Access Compliance Report

Public Rights-of-Way

(Pedestrian Signals)

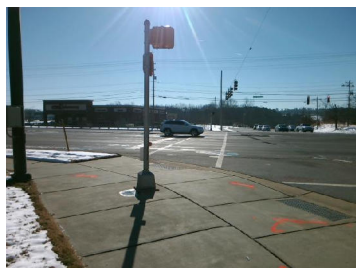
PROW/ADA: TMUTCD 4e.08, R404.2, R404.3, R406.2, R404.7.2

Possible Solutions: Replace Signal Push Button With APS Button on New Post. Remove & Relocate Sign.
